U.S. Steel Mining Co., Inc.
a Subsidiary of United States Steel Corporation

Re: Abatement Plans
NOV N84-2-13-1

U. S. STEEL MINING COMPANY, INC.
WESTERN DISTRICT
WELLINGTON COAL CLEANING PLANT
PROPOSED SLURRY DISCHARGE
CONTAINMENT BASIN
LOCATION MAP
DRAWN: W.J.C.
APPROVED:
SCALE: 1" = 200'
A9-1449
RECEIVED
SEP 19 1984
DIVISION OF OIL
GAS & MINING
PERMIT AREA BOUNDARY
PERMIT AREA BOUNDARY
PROPOSED PERMIT AREA EXTENSION
EXTENSION = 6.5 ACRES
CN=89
CN=84
ELEVATED PIPELINE
5425
5400
5375
5350
N
BERMS
PROPOSED BASIN AREA
DRAINAGE AREA
PERMIT AREA
PROPOSED SPOIL PILE

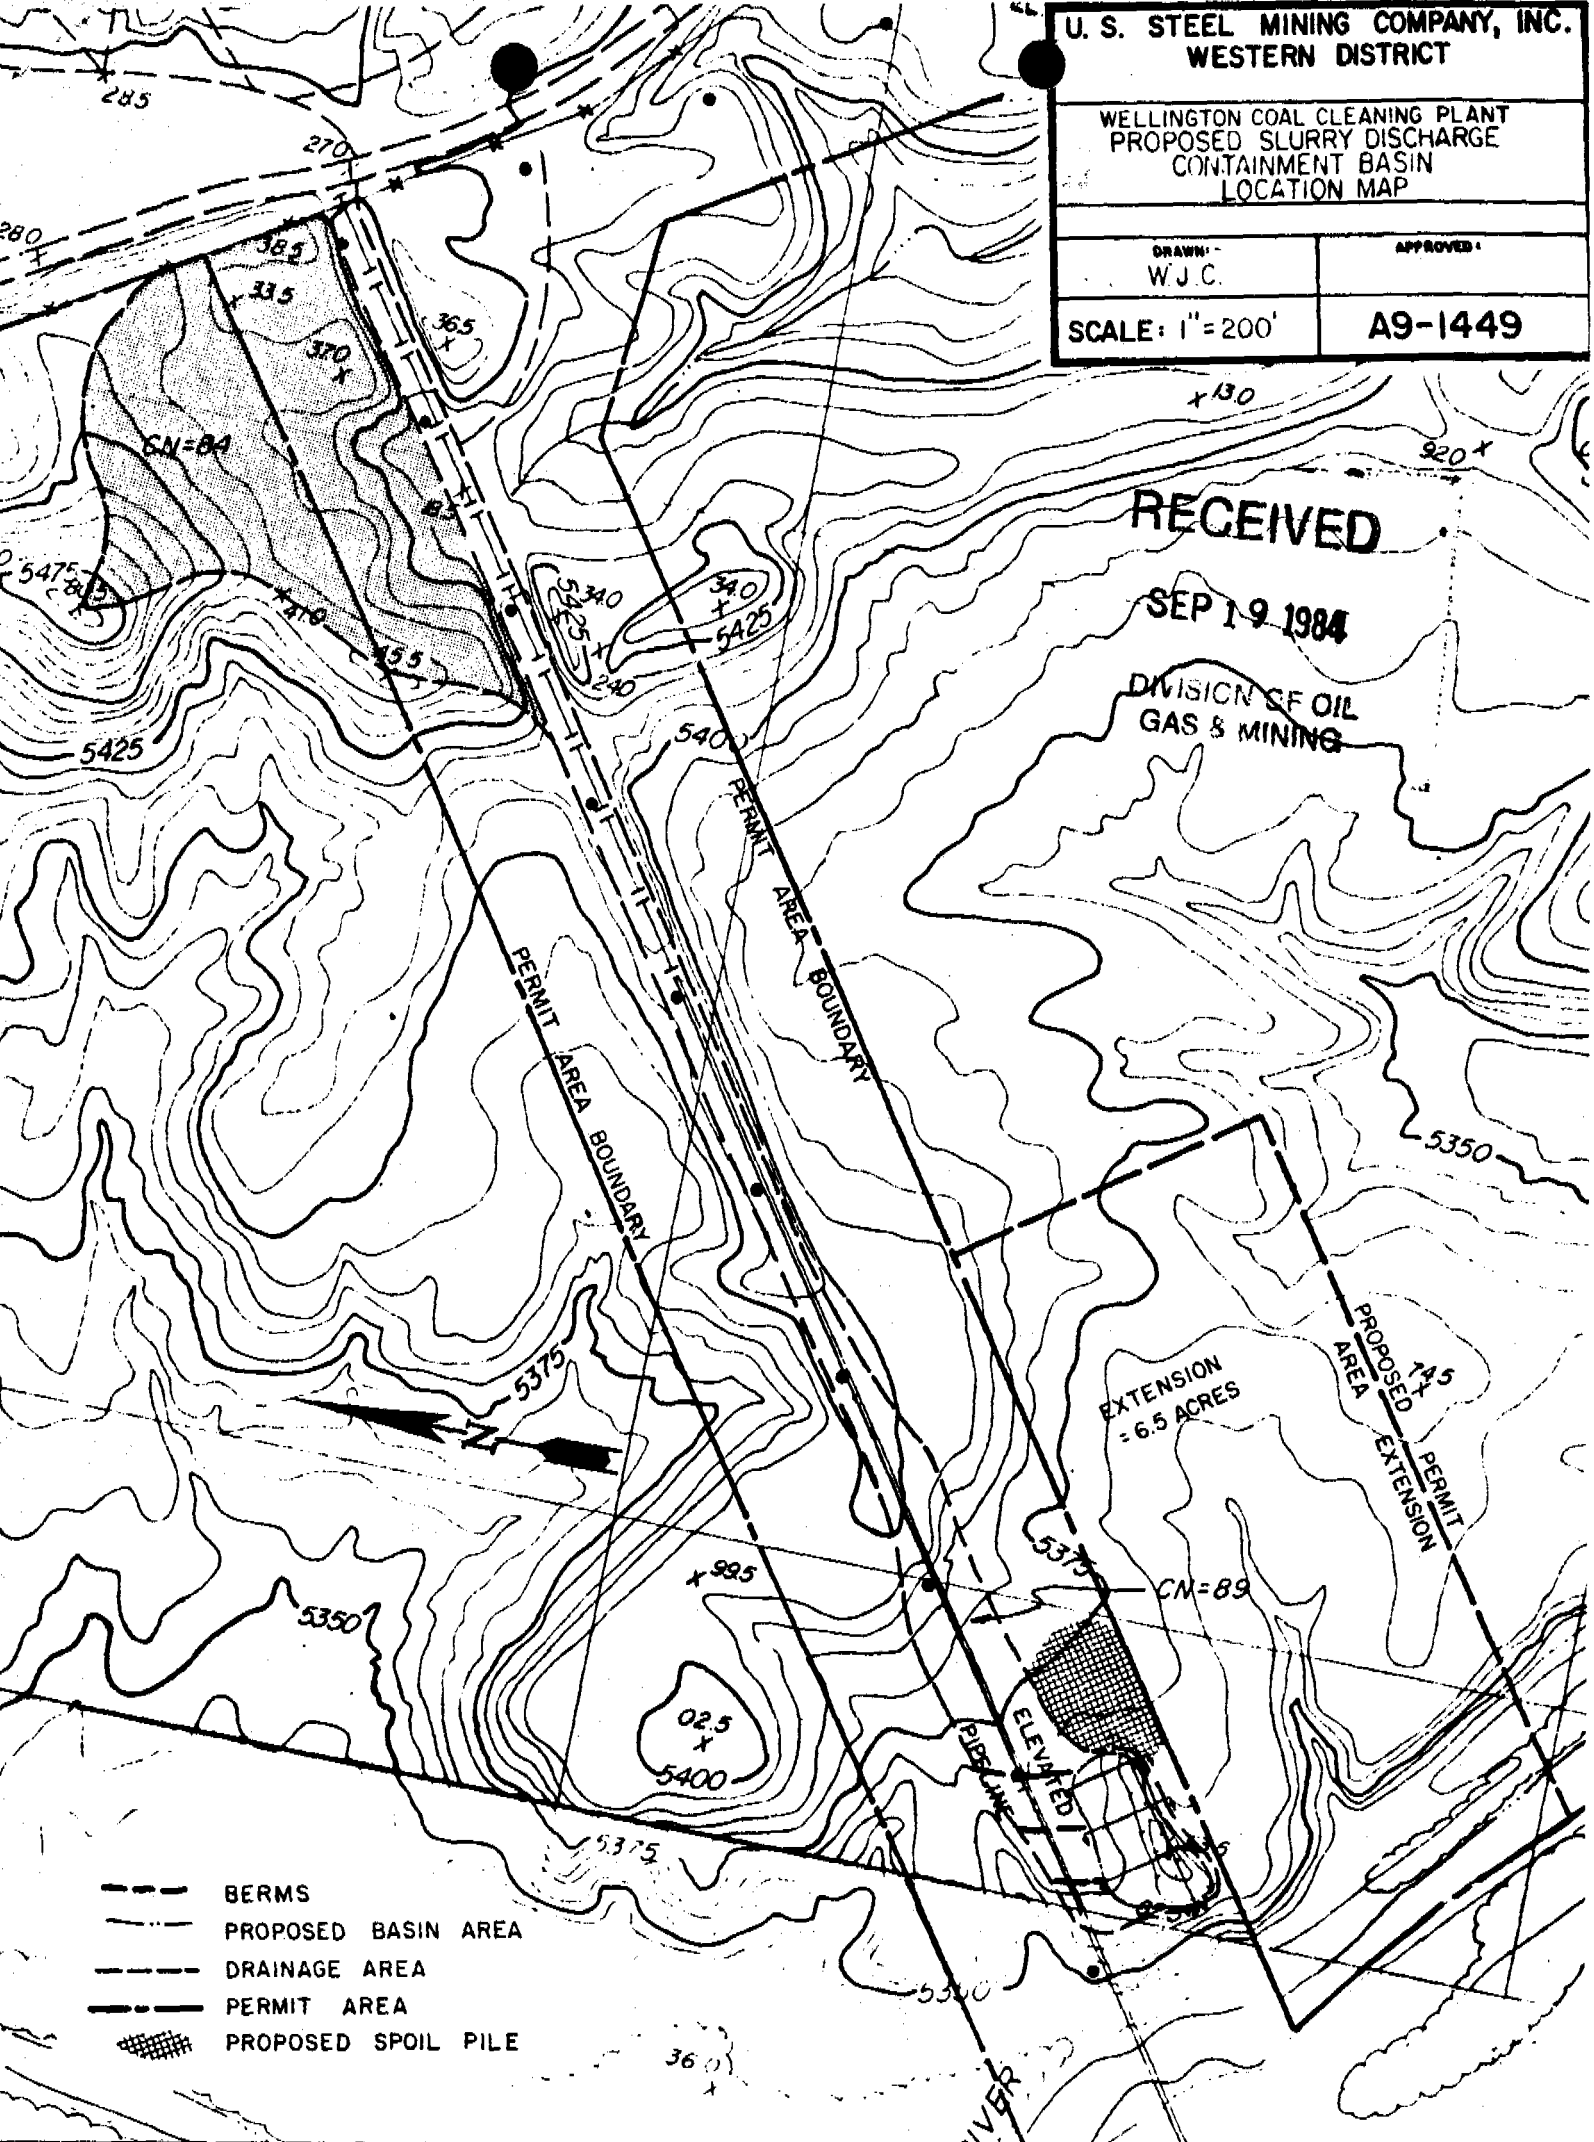
(2) Map A9-1449 which shows the hydrologic curve numbers and a proposed permit area extension.

The present containment basin is located very close to the permit area boundary. U. S. Steel Mining Co., Inc. proposes to extend the permit area as shown on map A9-1449. This extension will provide additional room to properly install the proposed structure. This change will also allow additional area should future modifications prove necessary.

The proposed modifications will be conducted in an area which was previously disturbed as was noted in the original submittal. Therefore, it will not be necessary to salvage and store topsoil. Spoil from the pond excavation will be stored as shown on map A9-1449.
